**DEDICATED FREIGHT CORRIDOR CORPORATION OF INDIA LIMITED**

**ADDENDUM NO. 2 DATED 08.11.2012**

**“Contract 101, 102 & 103: Design-Build Contract for Civil, Structures and Track Works”**

**ICB No.: HQ/EN/DB/Bhaupur – Khurja**

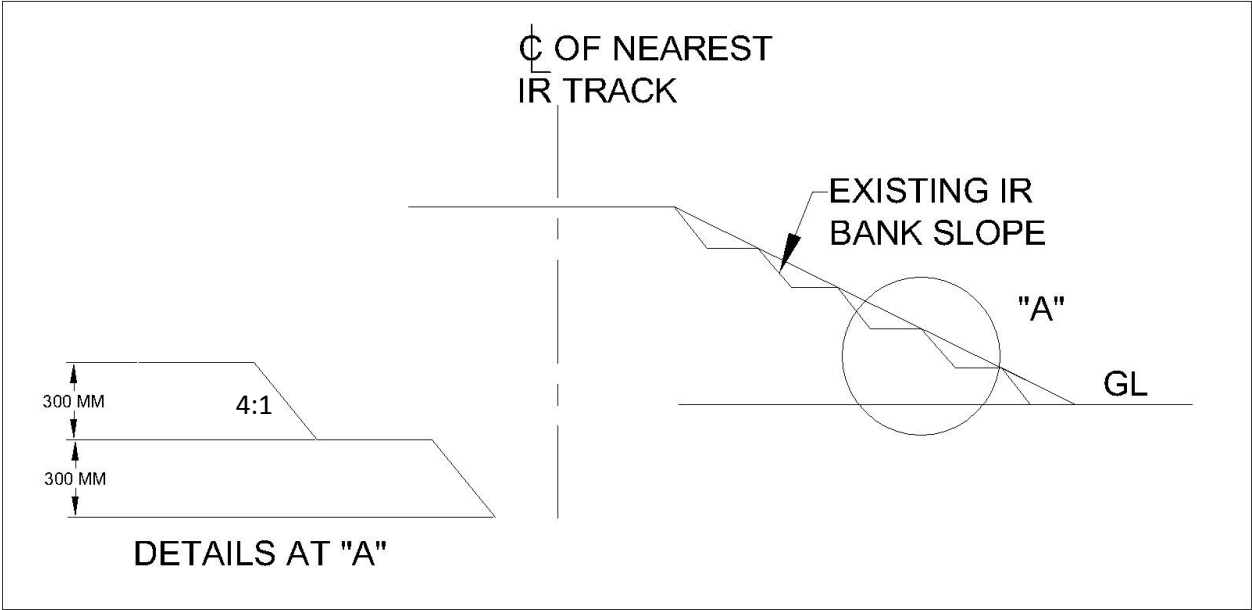
<p>earthwork is taken up, to provide proper bonding between old and new earthworks. It should be ensured that there is no humus material left on the benched slope. Care need to be taken to avoid entry of rain water into the formation from this weak junction to avoid development of weakness in formation, slope failure, maintenance problems due to uneven settlement.</p> <p>(2) Starting from the toe, benching at every 30cm height shall be done on the sloped surface of existing IR bank as in sketch below, so as to provide proper amalgamation between old and new earthwork. “</p>
--	--	--	--

<p style="text-align: center;"> <math>\text{C}</math> OF NEAREST IR TRACK </p> <p>EXISTING IR BANK SLOPE</p> <p>"A"</p> <p>GL</p> <p>300 MM</p> <p>4:1</p> <p>300 MM</p> <p style="text-align: center;">DETAILS AT "A"</p>
44.	Part-2 [Employer's Requirements], Volume-5 [Construction, Testing and Commissioning],	Sub Clause 16.0 (2) of Clause 16.0 [Construction-Bridges] (Page 201)	<p><b>Delete</b> the contents of Sub Clause 16.0 (2) <b>and replace as under:</b></p> <p>"(2) The construction methodology to be adopted for Rail Flyovers (RFO's) shall be such as to allow unhindered and safe movement of existing rail traffic with minimum number and duration of traffic block and incorporating suitable temporary arrangements conducive to working under running traffic."</p>
